Docket Number:	15-AAER-06
Project Title:	Small Diameter Directional LED Lamps and General Purpose LED Lamps
TN #:	206860
Document Title:	Greg Merritt Comments: Cree Comments - T20 45 Day language
Description:	N/A
Filer:	System
Organization:	Greg Merritt
Submitter Role:	Public
Submission Date:	12/7/2015 11:43:55 AM
Docketed Date:	12/7/2015

Cree Comments - T20 45 Day language

Cree Comments on Small Diameter Directional LED Lamps and General Purpose LED Lamps – Express Terms 45 Day Language

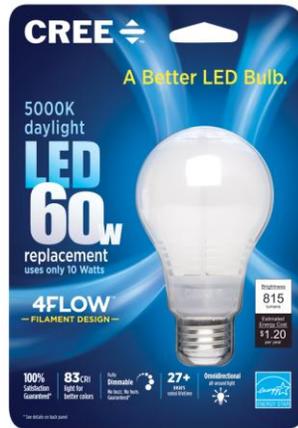
Comments: Without the ability to state a wattage comparison for Daylight (5000K) bulb, consumers will be forced to know what lumen output represents the bulb they're seeking. For example, they need to know 800 lumens to replace a 60W incandescent and 1600 lumens to replace a 100W incandescent.

Below are examples of our packaging for 2700K soft white and 5000K daylight bulbs. We indicate the color both through text and color treatment to help guide shoppers, in addition to the Lighting Facts label prominently displayed on the package.

Cree's Recommendation is to permit wattage or light output equivalency claims for higher CCT lamps to simplify the shopping and purchasing decisions for the consumer.
